Rail Coach Factory, Kapurthala

Sub: RODENT entry in SBC Panels of coaches.

CAI N O.: ED/CAI/034 Dated: 04.05.2024

**COACH ALTERATION INSTRUCTION SHEET TO
AVOID ENTRY OF RODENTS IN SWITCH BOARD
CABINETS IN LHB COACHES**

Fig.1: OLD D&ED

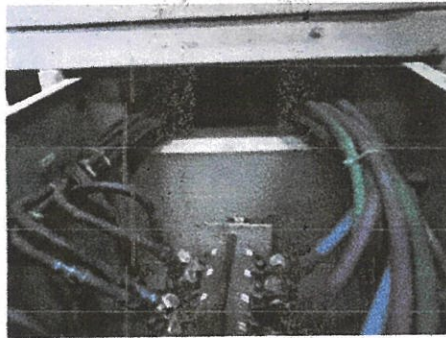
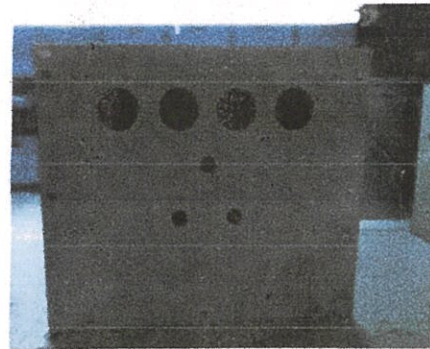
- a) In old design of Switch Board Cabinets, there is a rectangular slot (as shown in Fig. 1 below) for cable entry in D&ED (Disconnecting and Earthing device) and it is prone for rodent entry in D&ED of Switch Board Cabinets. In order to overcome this problem, RDSO has redesigned the D&ED with proper slots & end fittings (as shown in Fig.2 below) and the same has been implemented in all SBC of AC LHB coaches.

- c) Those existing 750V D&ED which are provided with rectangular slot, needs to be screwed with FRP grade polycarbonate sheet covering the cut-out with wire entry grooves cut in that and sealed with RTV sealant. This sheet can be replaced with proper end-fitting cut metallic sheet in IOH/POH. Further, the missing side wall in HT fuse compartment/missing roof top & side wall sheet in SBC may also be suitably covered with FRP grade polycarbonate sheet of proper thickness with wire entry grooves cut in that and sealed with RTV sealant.
